# Access Compliance Report

## Public Rights-of-Way

### (Curb Ramps)

Intersection ID: 46708	Main Street: REA_RD	Cross Street: BLAKENEY_PROFESSIONAL_DR	Location: E
ADA ID: 92EB921EF205	Ramp Type: PerpDiag	Initial Pass/Fail: Fail	Overall Compliance: No
Codes/Mitigation Info/Possible Solution		Field Measurements/Component Compliance

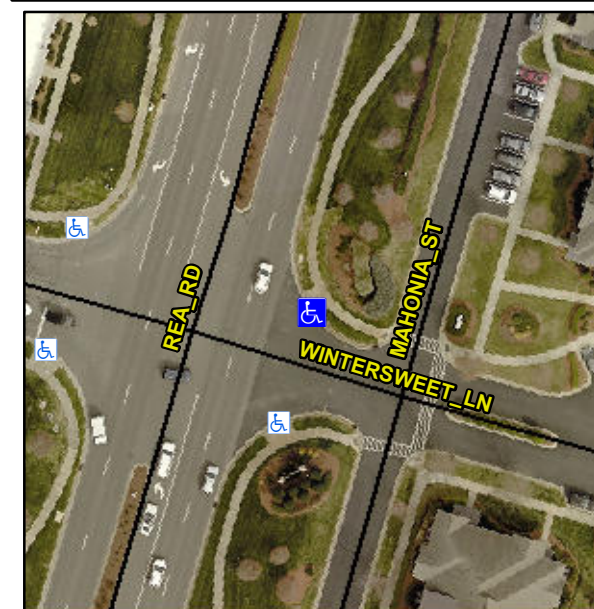
**R304.5.1, R304.2.2**

Compliance	Description	Data	Compliance	Description	Data
N/A	Ramp Length (in)	74.0	No	Ramp Slope (%)	13.6
No	Ramp Width (in)	40.0	Yes	Ramp XSlope (%)	1.5
N/A	Flare Type LT	N/A	N/A	Flare Type RT	N/A
N/A	Flare Slope LT (%)	N/A	N/A	Flare Slope RT (%)	N/A
N/A	Flare Traversable LT?	N/A	N/A	Flare Traversable RT?	N/A
N/A	Landing Length (in)	N/A	N/A	DWS Provided?	N/A
N/A	Landing Width (in)	N/A	N/A	DWS Contrast?	N/A
N/A	Landing Slope (%)	N/A	N/A	DWS Length (in)	N/A
N/A	Landing X Slope (%)	N/A	N/A	DWS Full Width?	N/A
N/A	Landing Curb? (Y/N)	N/A	N/A	DWS Offset (in)	N/A
N/A	Shared Landing?	N/A			
N/A	Gutter Ponding?	N/A	N/A	Gutter Slope (%)	N/A
N/A	Gutter Lip Ht (in)	N/A	N/A	Gutter X Slope (%)	N/A
N/A	Painted X Walk1?	No	N/A	Painted X Walk2?	No
	X Walk 1 Direction	To NW		X Walk 2 Direction	To SW
N/A	X Walk 1 Width (in)	N/A	N/A	X Walk 2 Width (in)	N/A
	X Walk 1 Slope (%)	4.3		X Walk 2 Slope (%)	1.3
	X Walk 1 X Slope (%)	1.2		X Walk 2 X Slope (%)	3.1

**Remove & Replace Curb Ramp With Two New Directional Ramps or Equivalent.**
